Report of the informal working group on Practical Classification Issues

Transmitted by the expert from the United States of America on behalf of the informal working group

Amendments to ST/SG/AC.10/C.4/2010/15

Amendments to ST/SG/AC.10/C.4/2010/16

5. Substantially similar mixtures bridging principle example

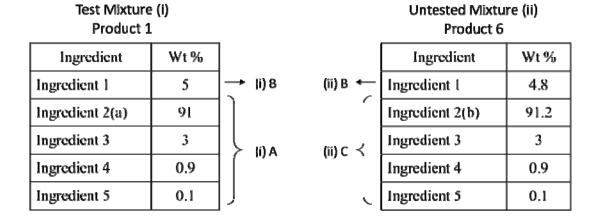
Background information (amend as indicated):

- 1. Ingredient 1 has been used in products ranging from 1.2 to 6.0 weight percent for years without reports of sensitization.
- 4-2. Existing animal test data on ingredient 1 indicates that it is a Category 1 skin sensitizer.
- 2. <u>Ingredient 1 has been used in products ranging from 1.2 to 6.0 weight percent for years with lack of evidence of skin sensitising properties (see table below "tested mixture information".)</u>

Answer: (amended as indicated):

The untested mixture (Product 6) is not classified <u>for skin sensitisation</u> based on the test data available for the similar tested mixture (Product 1).

Rationale: Insert the figure below after paragraph (d) and before sub-paragraph (i).
